INSTRUCTIONS FOR UPDATING YOUR ER

To update your copy of the Clinton Power Station - Units 1 and 2 Environmental Report - Operating License Stage, please remove and destroy the following pages and figures and insert the Supplement 1 pages and figures as indicated.

**CLINTON POWER STATION
UNITS 1 AND 2**
ENVIRONMENTAL REPORT-OPERATING LICENSE STAGE

FIGURE 5.1-0A
THERMAL DEMONSTRATION
FIGURE 6-3

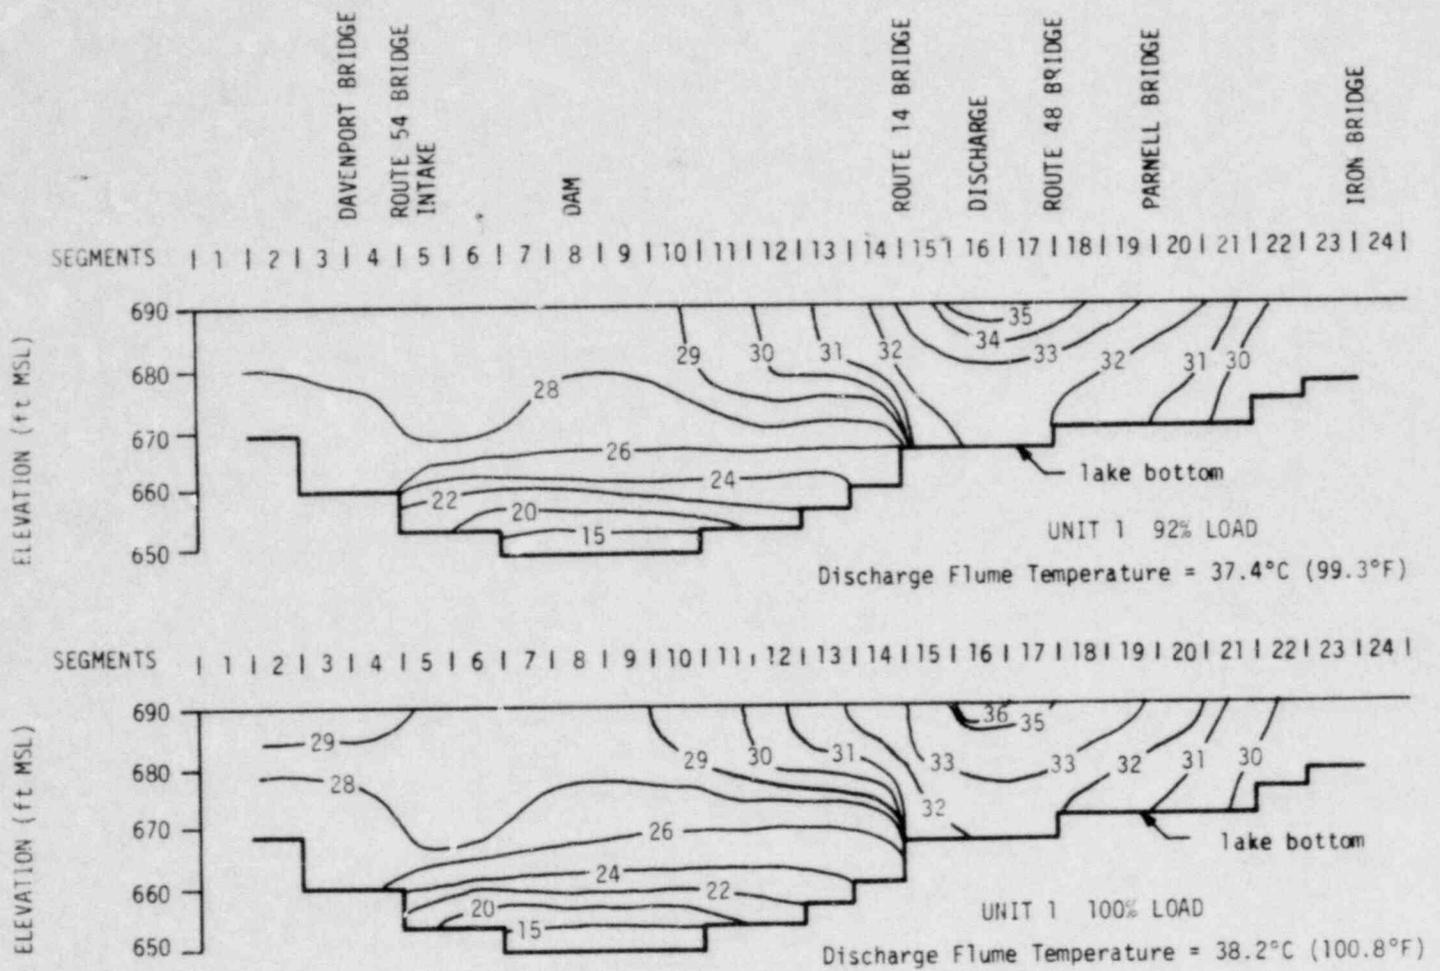
The Salt Creek inflow enters Lake Clinton at Segment 23 on the included figures as defined by the LARM model. These figures, obtained from the Clinton Power Station Thermal Demonstration, July 1980 to the Illinois Pollution Control Board, indicate that the temperatures at this point resulting from unconstrained one-unit operation (see Figure 5.1-0A) and two-unit operation constrained to 95° F (see Figure 5.1-0B) are within 2° F of ambient lake temperatures (see Figure 5.1-0C). These temperature profiles, calculated by the LARM model, clearly indicate that the effects of thermal plume intrusion on Salt Creek are minimal.

FIGURE 2.5-278

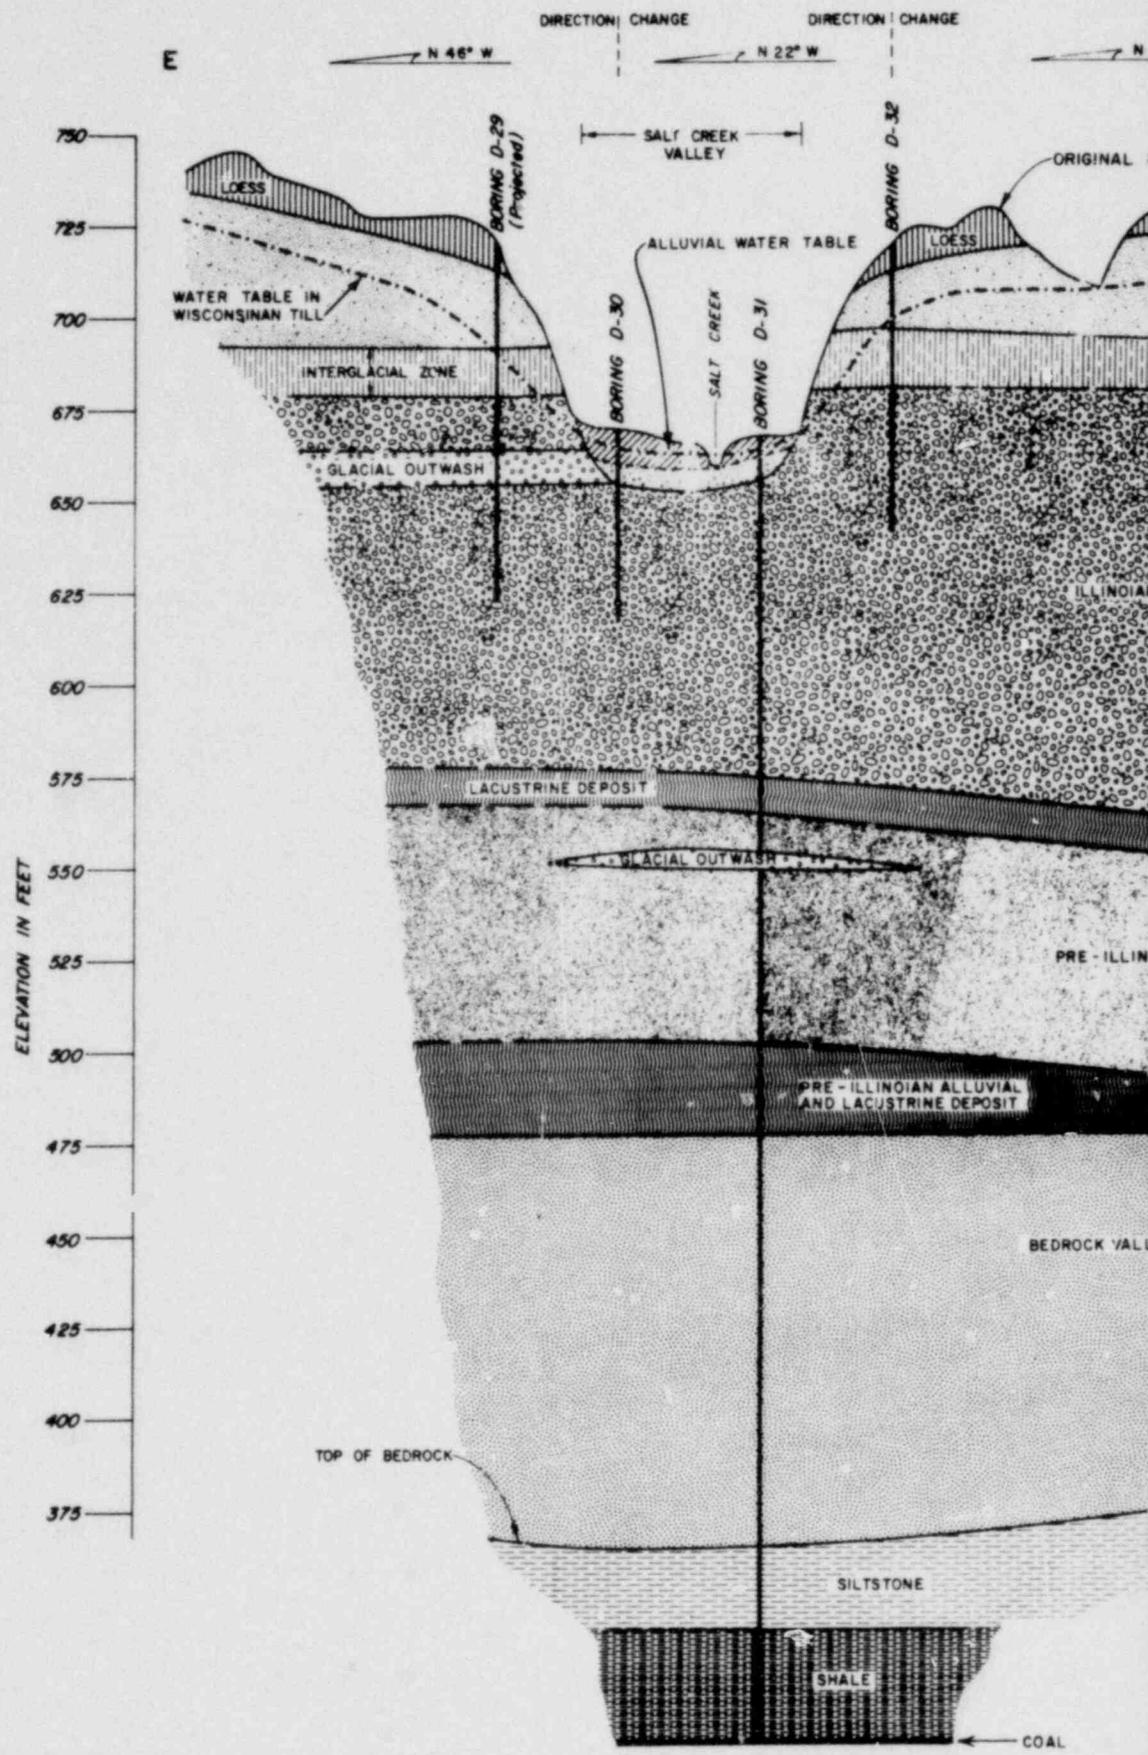
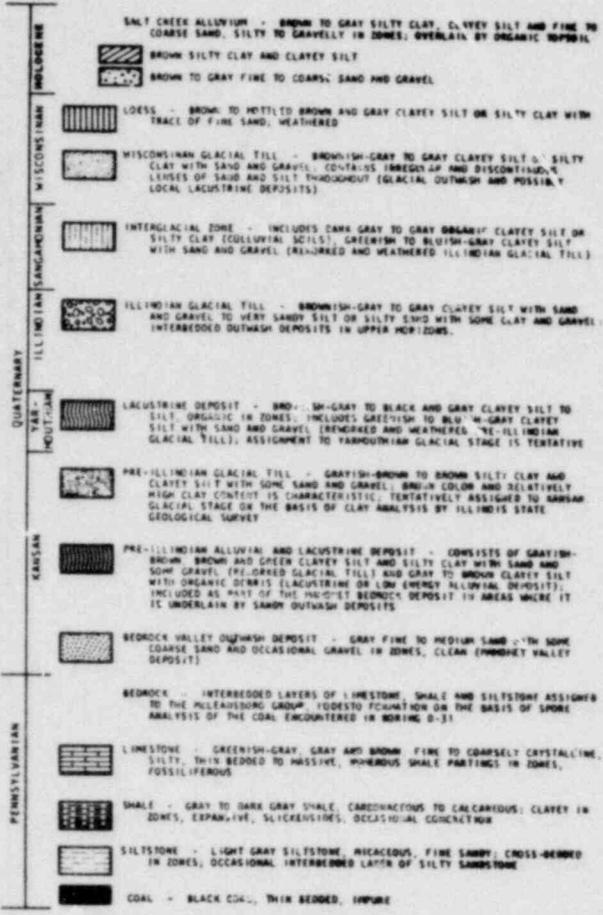
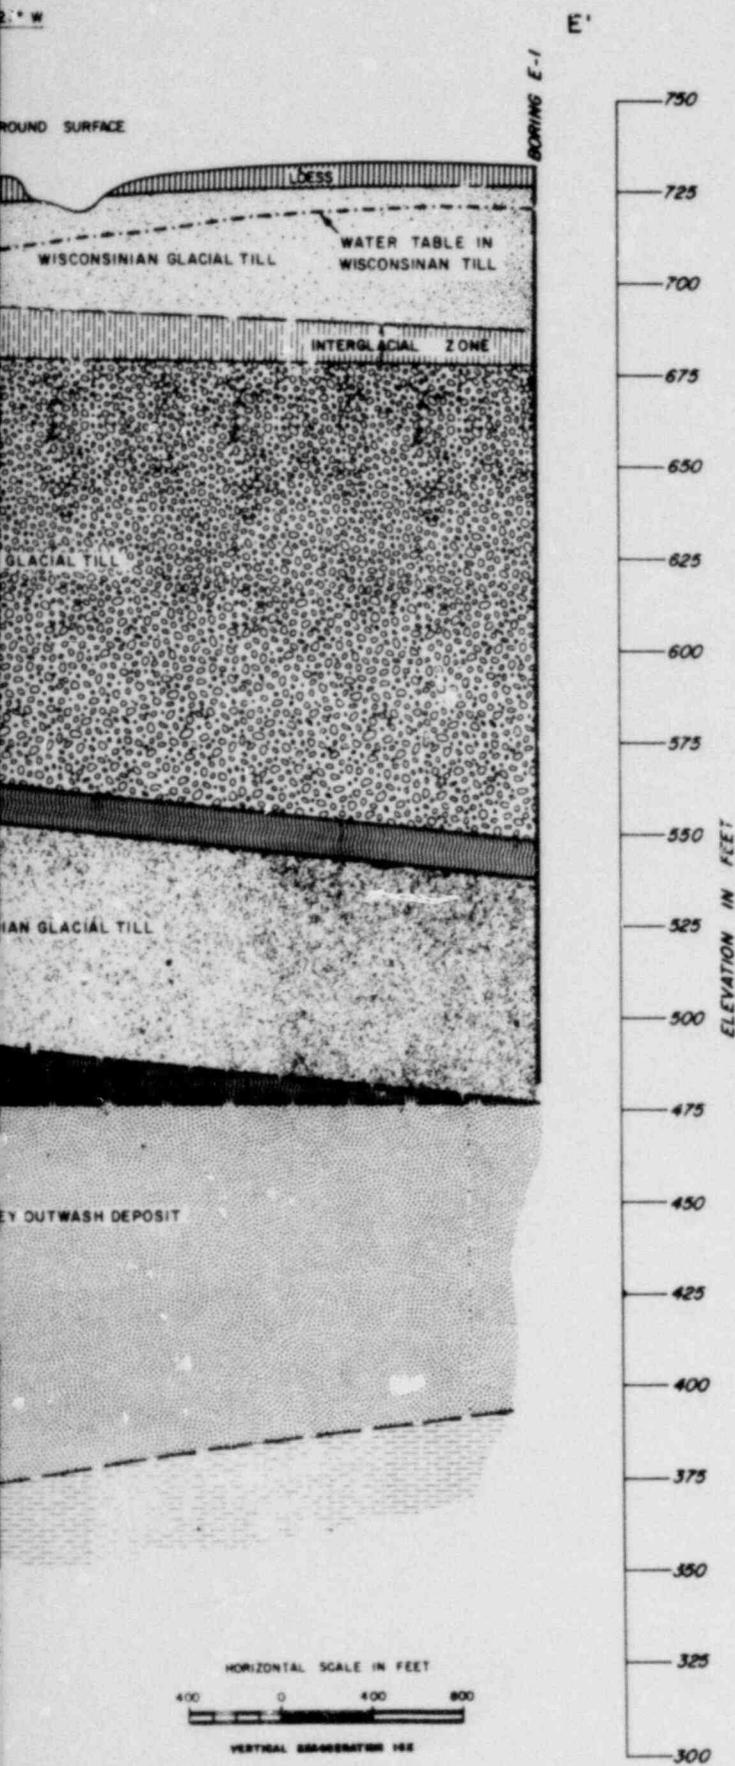
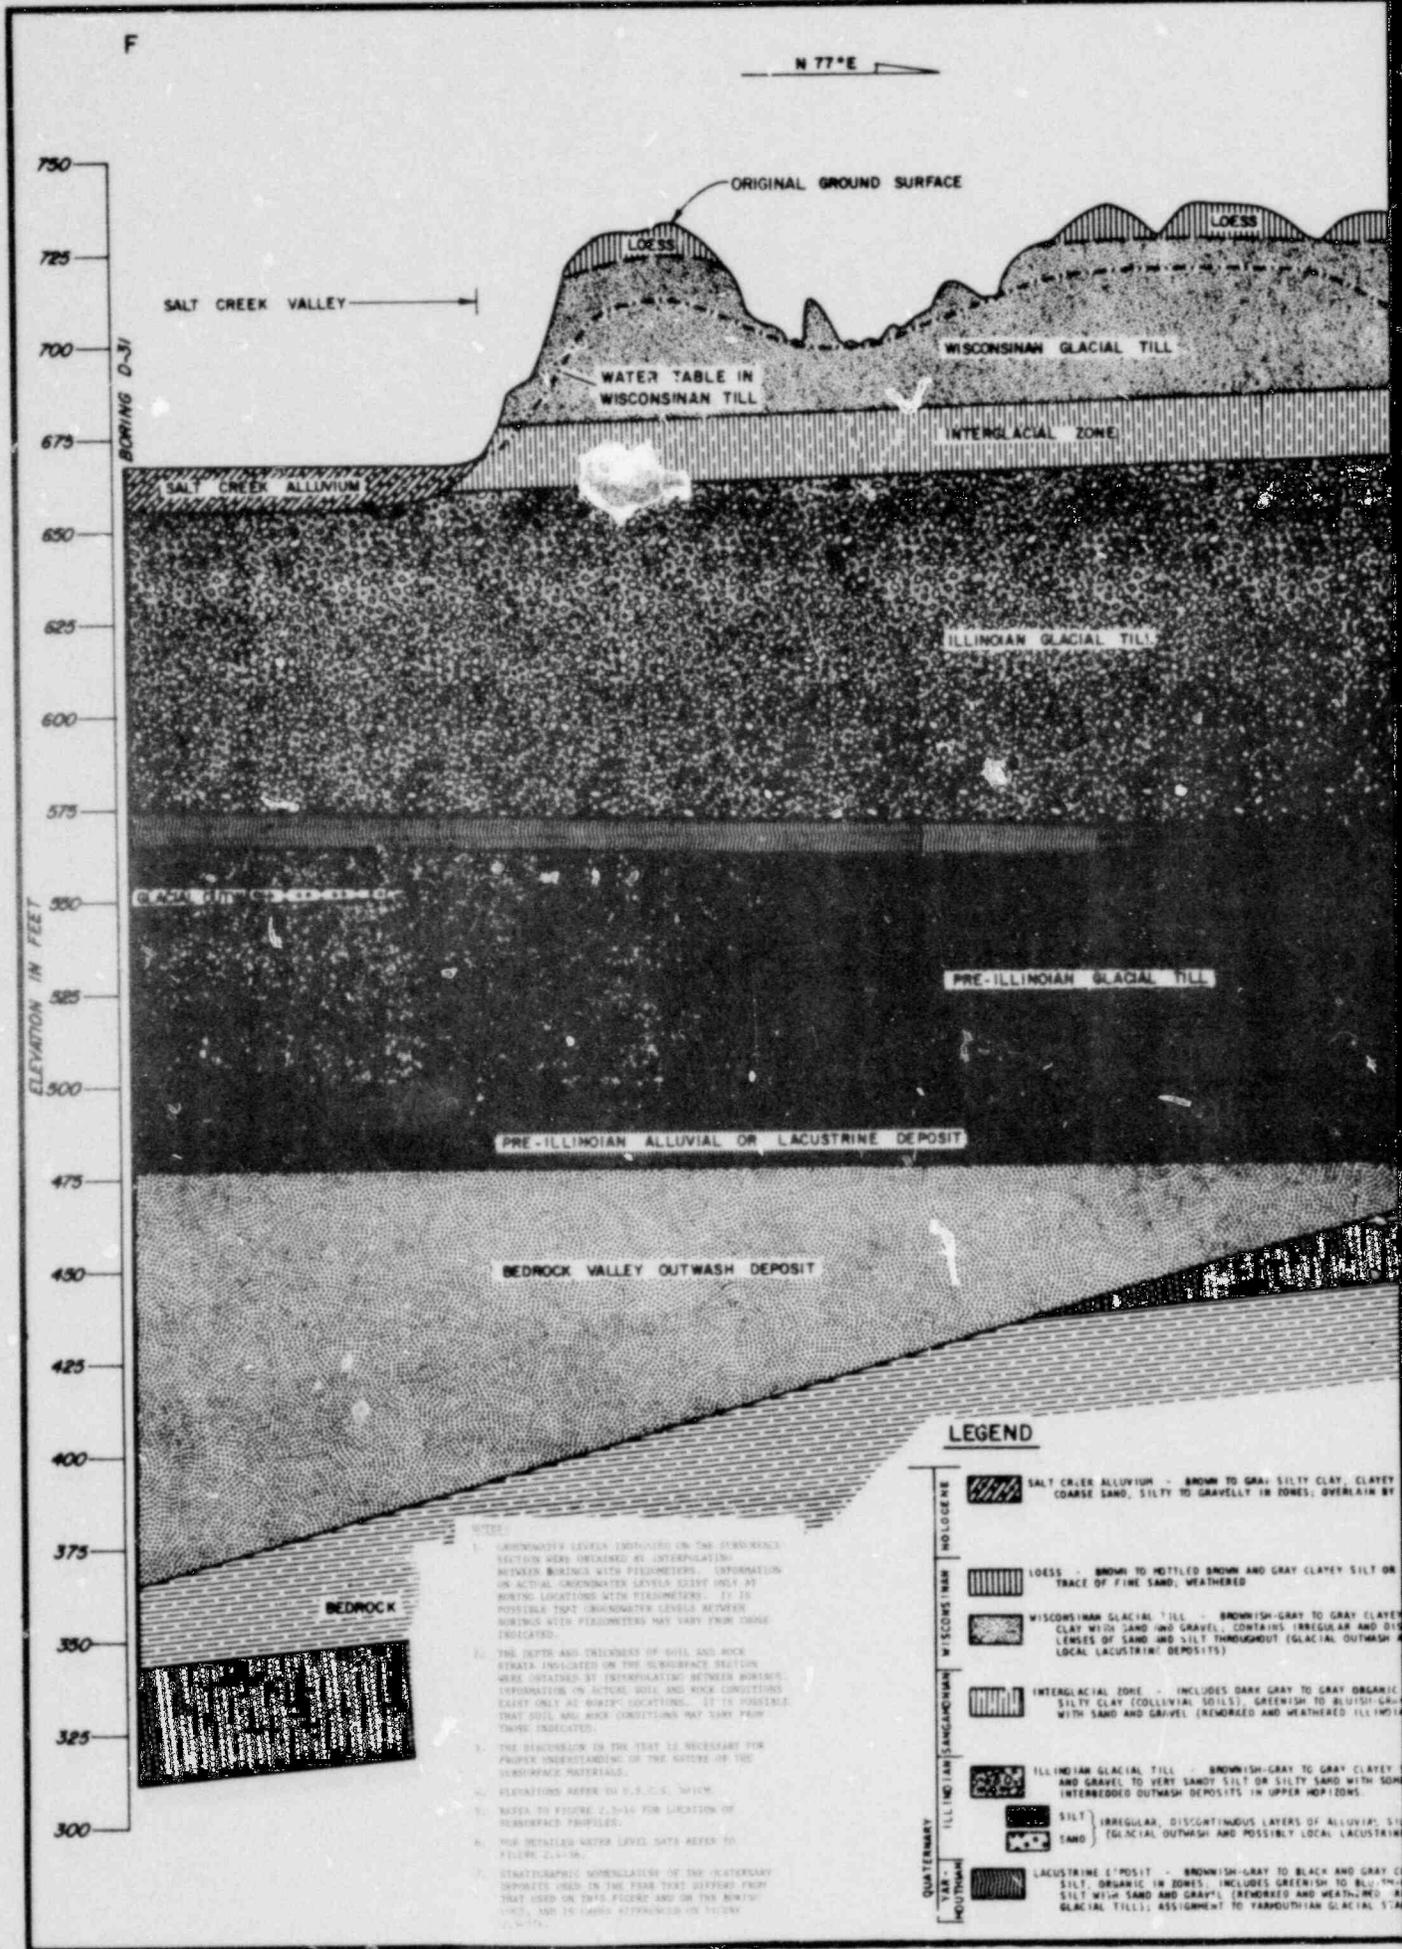
The topography or shape of the lake bottom is shown on Figure 2.4-5 of the CPS Environmental Report-Operating License Stage [CPS-ER(OLS)]. The contours shown on this figure indicate that the landform of the lake bottom is primarily a floodplain of Salt Creek. This landform is a recent modification of Quaternary landforms due to flooding.

A discussion of the agricultural soil associations is presented in Subsection 2.5.3.1.1 of the CPS-ER(OLS). The locations of the agricultural soil associations are shown on Figure 2.5-3. The soil associations of the lake bottom are the Huntsville-Sawmill Association, the Alexis-Littleton-Camden Association, and the Strawn-Hennepin Association. Subsection 2.5.3.1.1 discusses the geologic units from which the soils developed. The agricultural soils are generally developed in the upper 5 feet of the Quaternary deposits (Smith and Smith 1940).

The Huntsville-Strawn Association shows little or no profile development and varies in character according to the recent sediments of which it is composed. The Alexis-Littleton-Camden Association has an upper layer 3 to 8 inches thick composed of silt loam. The subsoil begins at 10 to 15 inches and is composed of yellowish-brown clay loam. Below 40 to 60 inches, stratified sands and gravels are found. The Strawn-Hennepin Association has an upper soil layer of silt loam. The subsurface is a grayish-yellow silt loam, and the subsoil, which begins at a depth of about 10 to 12 inches, is a yellow silty clay loam that often contains considerable gravel. Below 20 to 40 inches, friable calcareous till is found. The Strawn-Hennepin Association makes up less than 400 acres of the entire lake bottom.

Below the agricultural soils are various Quaternary units overlying Pennsylvanian-age bedrock. Figures 2.5-278 and 2.5-279 from the CPS Final Safety Analysis Report (FSAR) have been included in this response to show the typical relationship of the Quaternary units. A complete discussion of site stratigraphy is presented in FSAR Subsection 2.5.1.2.2.
